REF	QTY	PART or DRWG No.	DESCRIPTION	MATERIAL
PARTS and MATERIAL LIST				
LIGO CALIFORNIA INSTITUTE OF TECHNOLOGY MASSACHUSETTS INSTITUTE OF TECHNOLOGY				
STIFFENER, VERT., REAR SUPPORT				
CAD FILE D980560-C			SIZE C	DWG. NO. D980560-C
SCALE 1 : 1			SHEET 1 OF 1

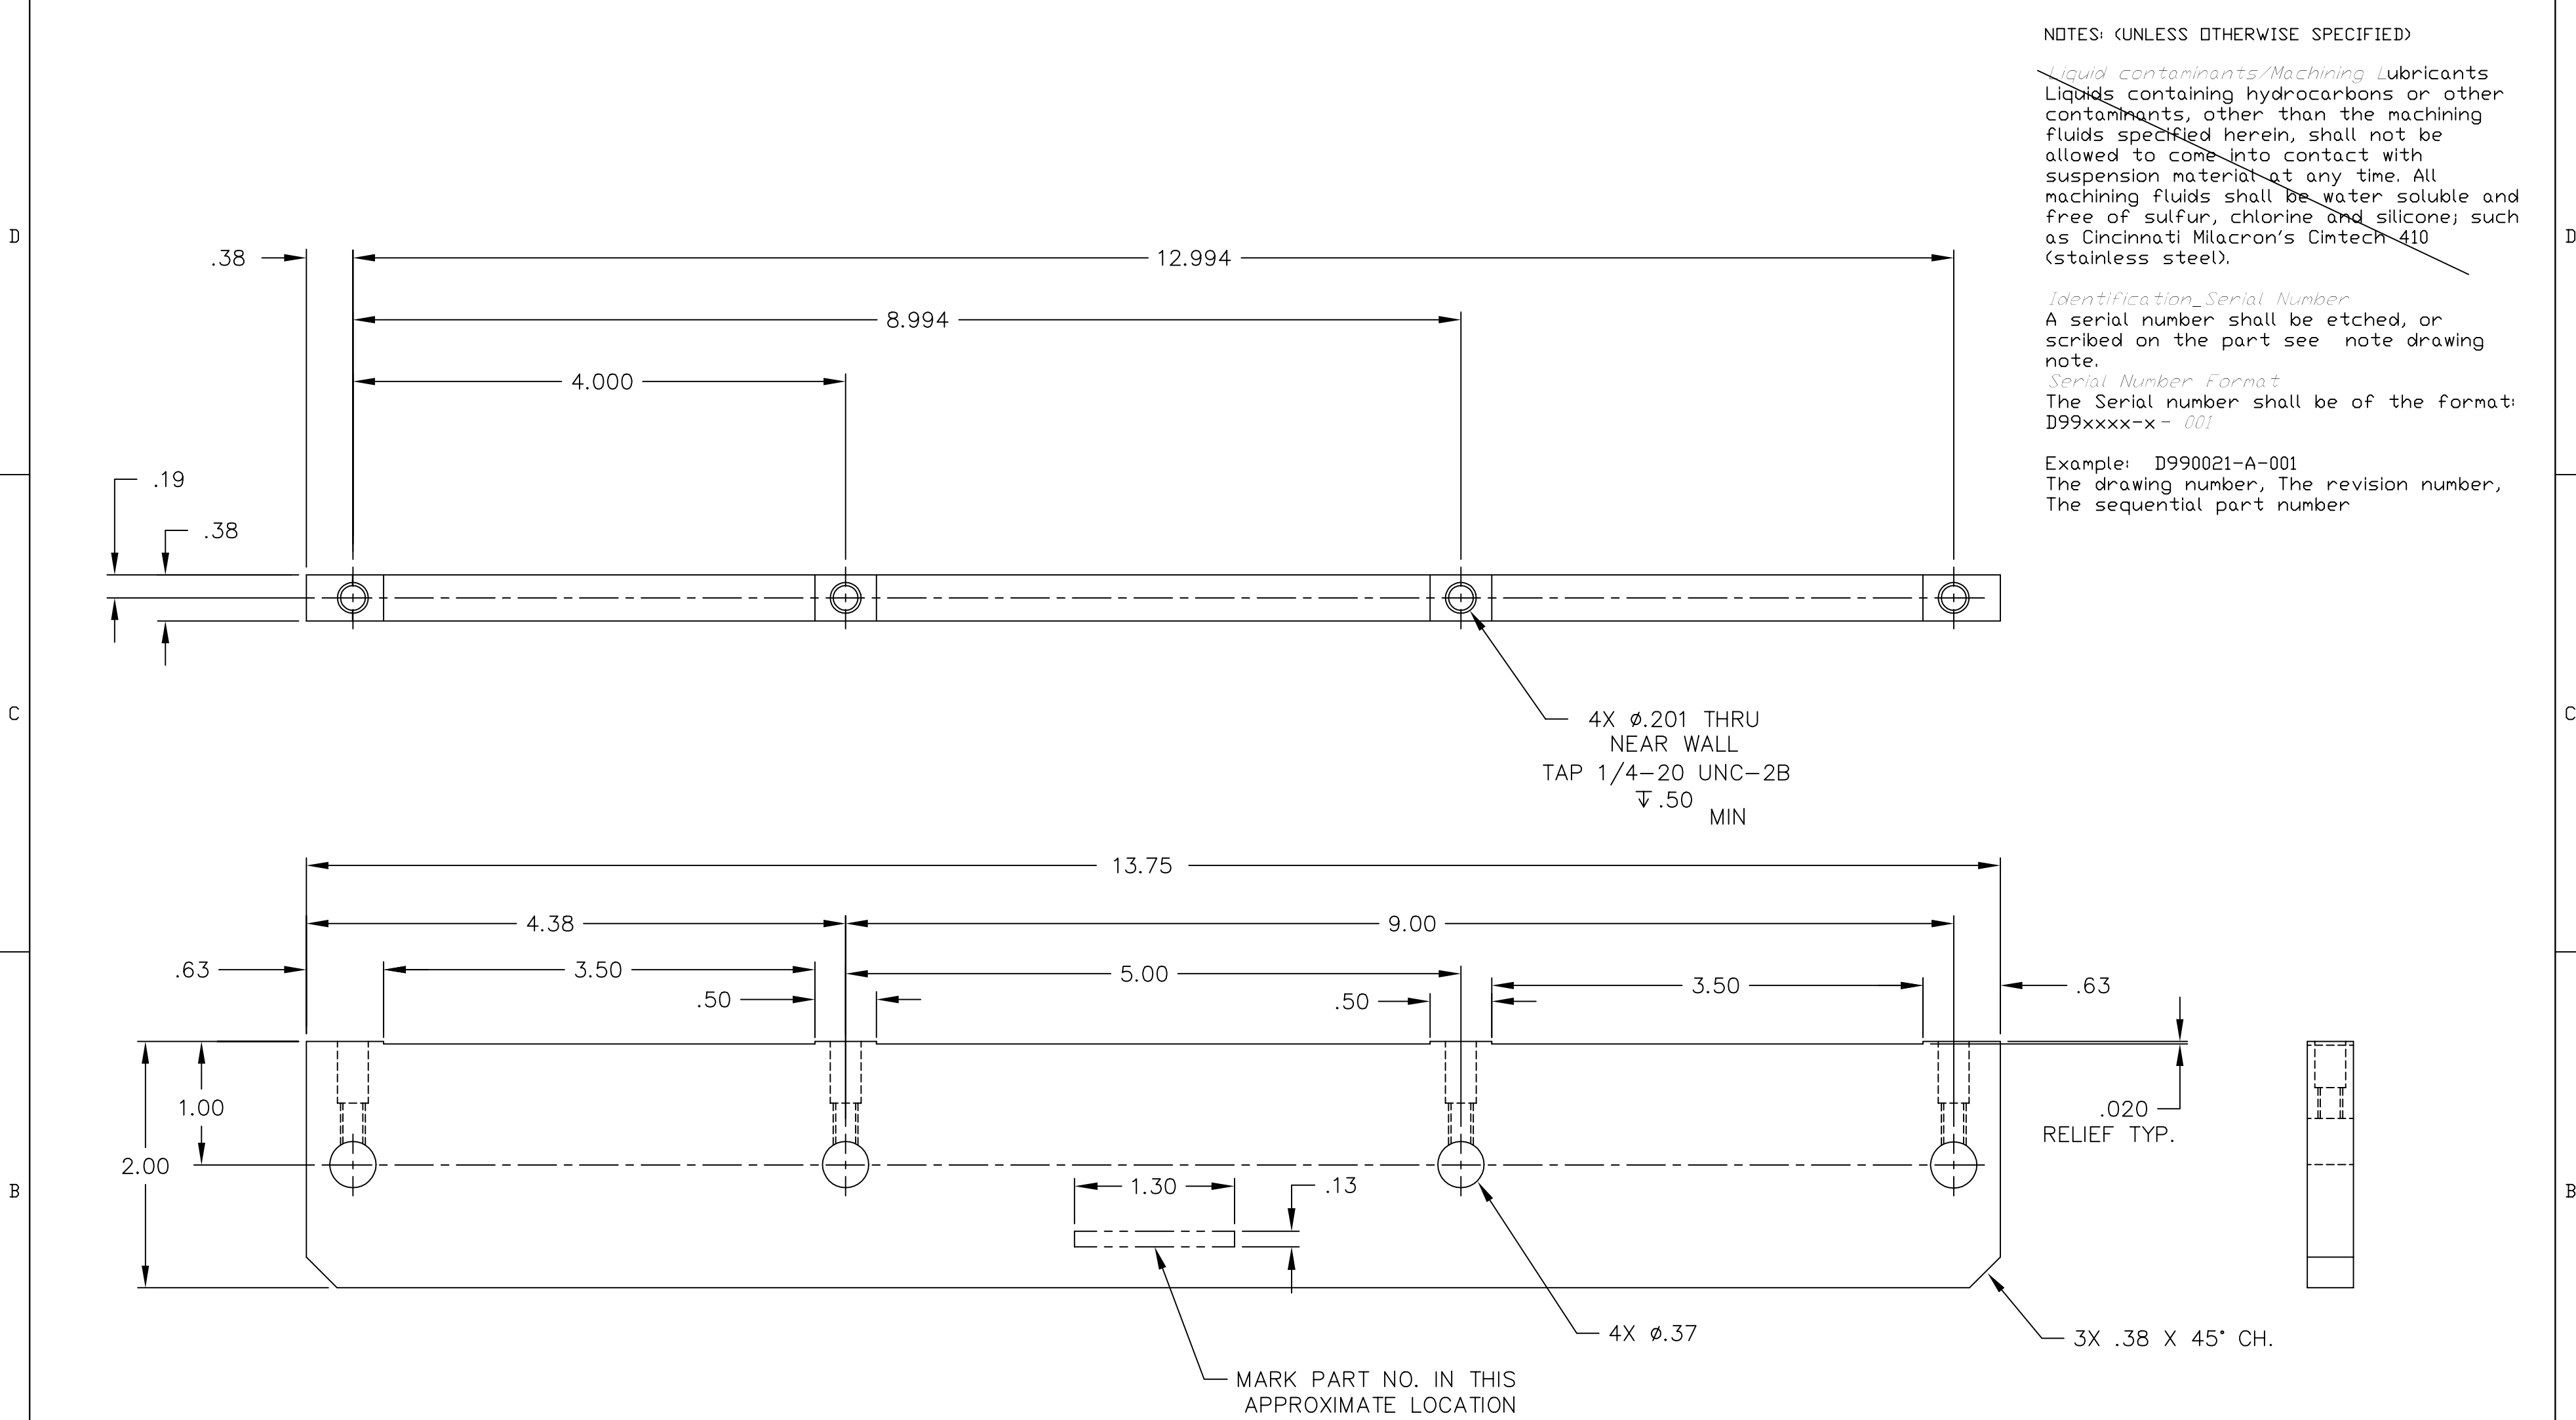
~~Liquid contaminants/Machining Lubricants~~
 Liquids containing hydrocarbons or other contaminants, other than the machining fluids specified herein, shall not be allowed to come into contact with suspension material at any time. All machining fluids shall be water soluble and free of sulfur, chlorine and silicone; such as Cincinnati Milacron's Cimtech 410 (stainless steel).
